## HISTORIC AND DESIGN REVIEW COMMISSION

**HDRC CASE NO:** 2015-299  
**ADDRESS:** 320 E LOCUST  
**LEGAL DESCRIPTION:** NCB 1739 BLK 2 LOT 6  
**ZONING:** MF33 H  
**CITY COUNCIL DIST.:** 1  
**DISTRICT:** Tobin Hill Historic District  
**APPLICANT:** Dan Gonzalez  
**OWNER:** Peter Krulevitch  
**TYPE OF WORK:** Accessory structure  
**REQUEST:**

The applicant is requesting a Certificate of Appropriateness for approval to:

1 SITE PLAN  
SCALE: 1" = 20'-0"

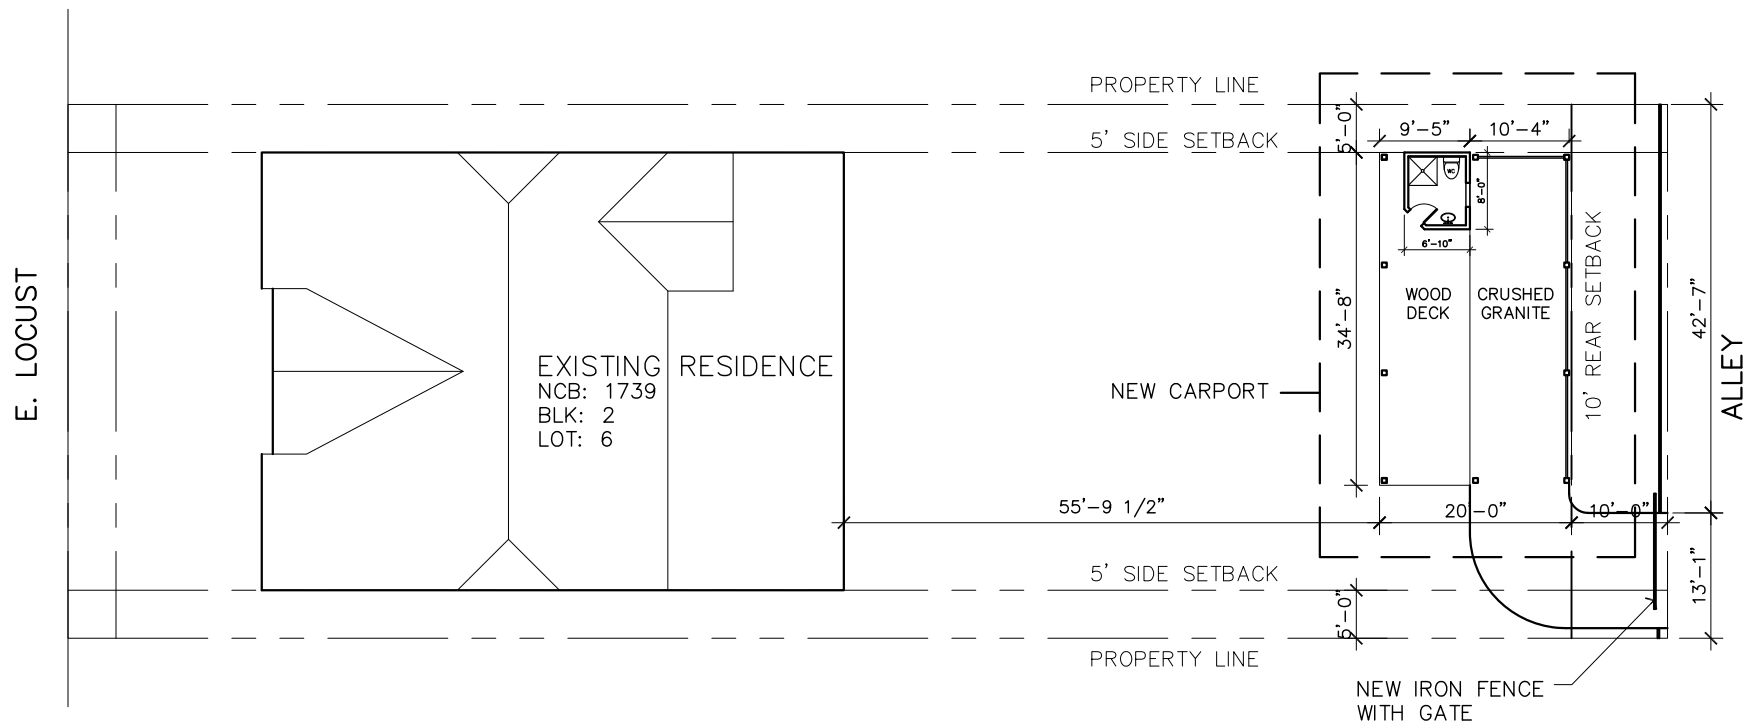
- f. According to the Guidelines for New Construction 4.B.ii., setbacks should follow historic patterns of similar structures along the streetscape or district for new garages and outbuildings. The applicant has noted the proposed carport to be located at the southeast, rear corner of the lot with a 10' rear setback and a 5' side setback. This is consistent with the Guidelines.

**5** FENCE ELEVATION  
SCALE: 1/4" = 1'-0"

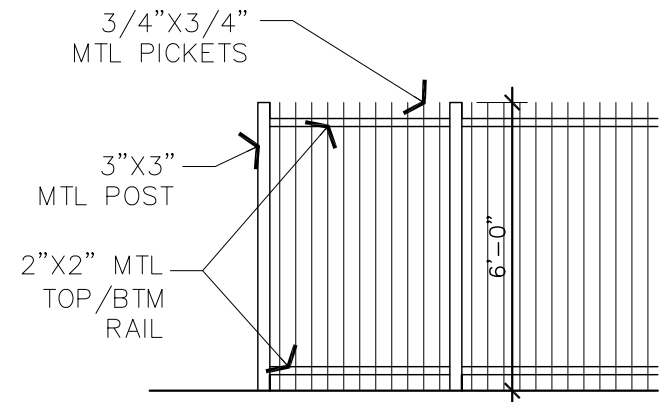
- h. The applicant proposes to install a 6' high painted metal fence at the rear of the property. The proposed painted

metal fence design and location is consistent with Guidelines.

- i. The applicant's proposed fence height of 6'-0" is the maximum allowable height for the rear of property, per UDC Section 35-514.
- j. The applicant proposes a 14' high gate attached to the 6' high fence at rear of the property. The 14' height exceeds the maximum allowable height per UDC Section 34-514. This is not consistent with the Guidelines.

- i. The applicant use a standing seam metal roof featuring panels that are 18 to 21 inches in width, ensure that seams are an appropriate height (1 to 2 inches), use a crimped ridge seam that is consistent with the historic application, use of a low profile ridge cap and use a galvalume finish.
- ii. The applicant reduces the overall height of the proposed 14' gate to match proposed 6' fence height, to be consistent with Guidelines 5.B.i., 5.B.iii. and UDC Section 35-514.
